| | UNITED STATES PARTMENT OF THE II UREAU OF LAND MANA | OCD Artesia | FORM APPROVED OMB NO. 1004-0135 Expires: July 31, 2010 | | |
|--|---|--|--|--|--|
| 1. Type of Well ☐ Gas Well ☐ Oth | 8. Well Name and No. COTTON DRAW | UNIT 206H | | | |
| 2. Name of Operator DEVON ENERGY PRODUCT | 9. API Well No. 30-015-42072-0 | | | | |

Primary/Secondary wellhead schematics Revised Cement Table Revised BOP Notes/Schematic Cotton Draw Unit 206 Revised Cement Table

Cotton Draw Unit 206H Revised BOP

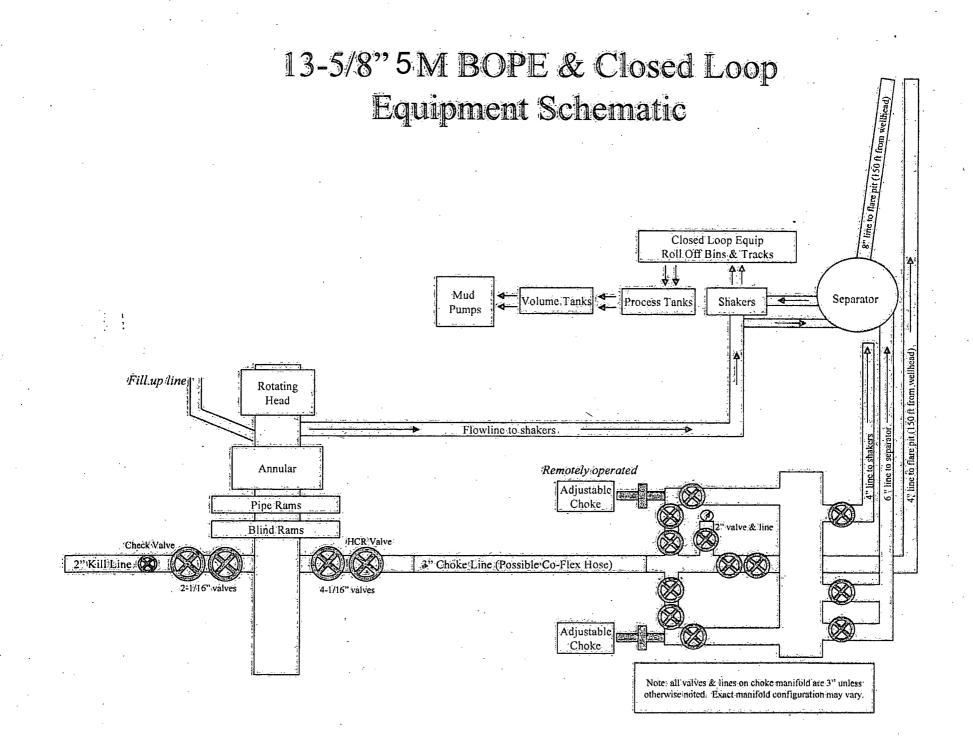
Devon requests a variance to use a flexible line with flanged ends between the BOP and the choke manifold (choke line). The line will be kept as straight as possible with minimal turns

Devon requests a variance to use a flexible line with flanged ends between the BOP and the choke manifold (choke line); **if an H&P rig drills this well. Otherwise no flex line is needed**. The line will be kept as straight as possible with minimal turns.

- 2. Variance approved to use flex line from BOP to choke manifold. Check condition of flexible line from BOP to choke manifold, replace if exterior is damaged or if line fails test. Line to be as straight as possible with no hard bends and is to be anchored according to Manufacturer's requirements. The flexible hose can be exchanged with a hose of equal size and equal or greater pressure rating. Anchor requirements, specification sheet and hydrostatic pressure test certification matching the hose in service, to be onsite for review. These documents shall be posted in the company man's trailer and on the rig floor. If the BLM inspector questions the straightness of the hose, a BLM engineer will be contacted and will review in the field or via picture supplied by inspector to determine if changes are required (operator shall expect delays if this occurs).

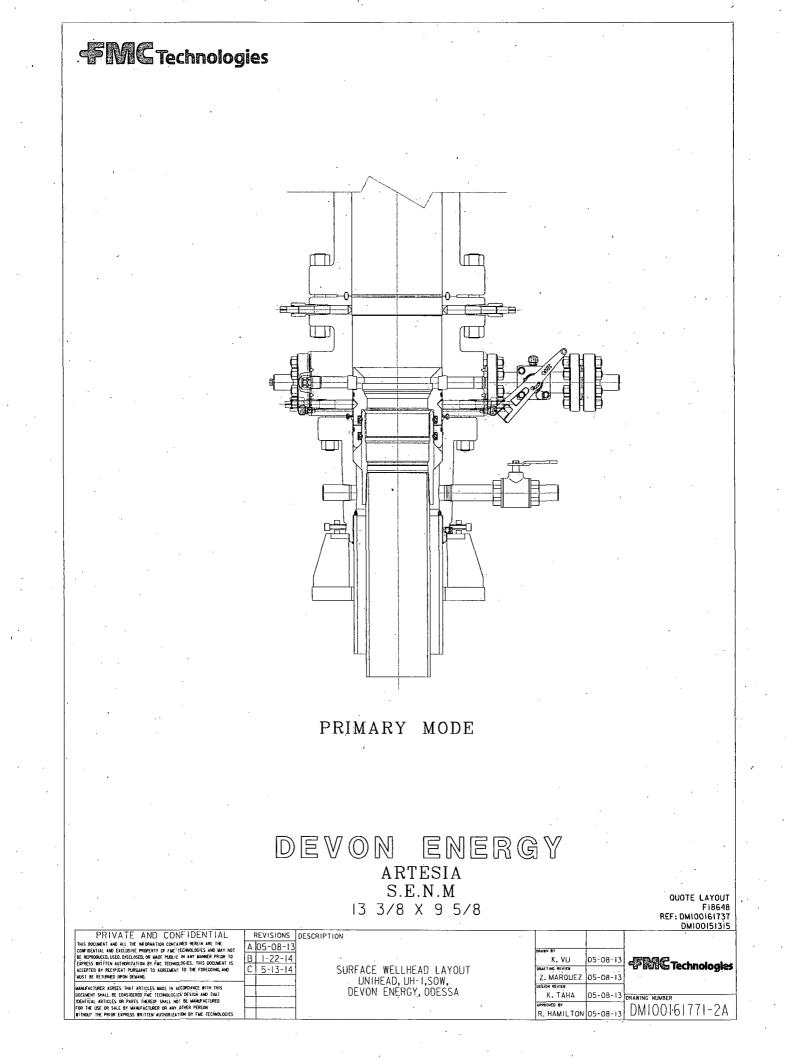
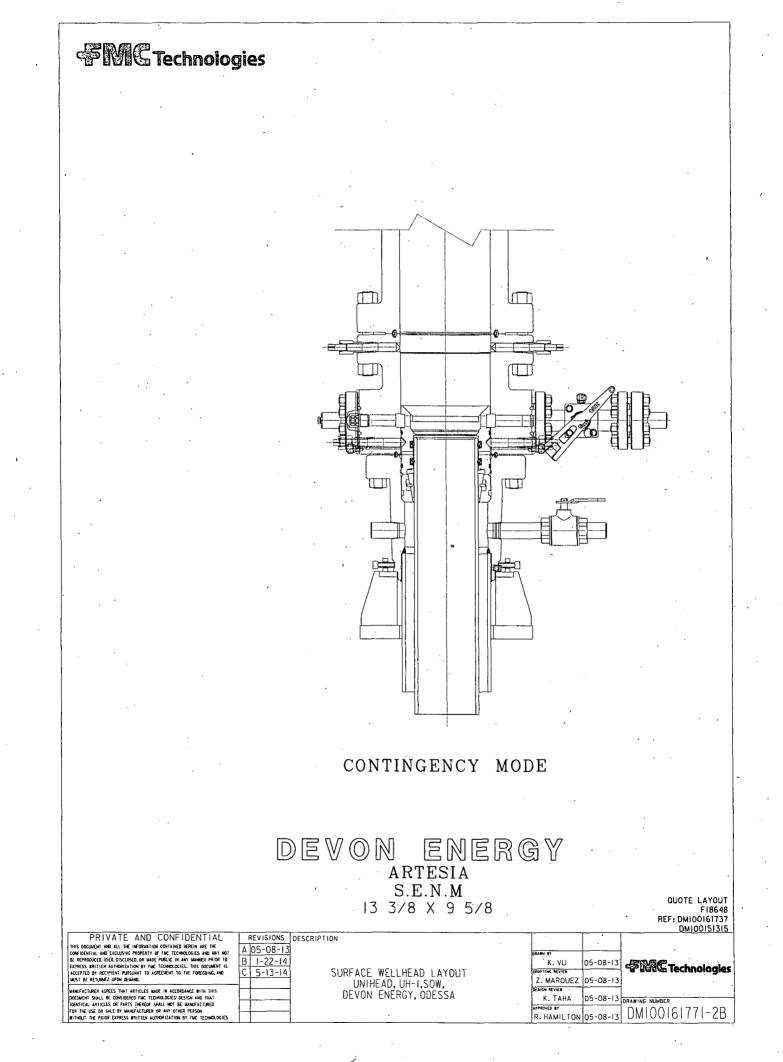
A multibowl wellhead is being used. The BOP will be tested per Onshore Order #2 after installation on the surface casing which will cover testing requirements for a maximum of 30 days. If any seal subject to test pressure is broken the system must be tested.

Devon proposes using a multi-bowl wellhead assembly (FMC Uni-head). This assembly will only be tested when installed on the surface casing. Minimum working pressure of the blowout preventer (BOP) and related equipment (BOPE) required for drilling below the surface casing shoe shall be 5000 (5M) psi.

- FMC representative will install the test plug for the initial BOP test.
- FMC will install a solid steel body pack-off to completely isolate the lower head after cementing intermediate casing. After installation of the pack-off, the pack-off and the lower flange will be tested to 5M, as shown on the attached schematic. Everything above the pack-off will not have been altered whatsoever from the initial nipple up. Therefore the BOP components will not be retested at that time.

- 3. Operator has proposed a multi-bowl wellhead assembly. This assembly will only be tested when installed on the surface casing. Minimum working pressure of the blowout preventer (BOP) and related equipment (BOPE) required for drilling below the surface casing shoe shall be 5000 (5M) psi.

- a. Wellhead shall be installed by manufacturer's representatives, submit documentation with subsequent sundry.
 - b. If the welding is performed by a third party, the manufacturer's representative shall monitor the temperature to verify that it does not exceed the maximum temperature of the seal.

- c. Manufacturer representative shall install the test plug for the initial BOP test.
 - d. Operator shall perform the intermediate casing integrity test to 70% of the casing burst. This will test the multi-bowl seals.
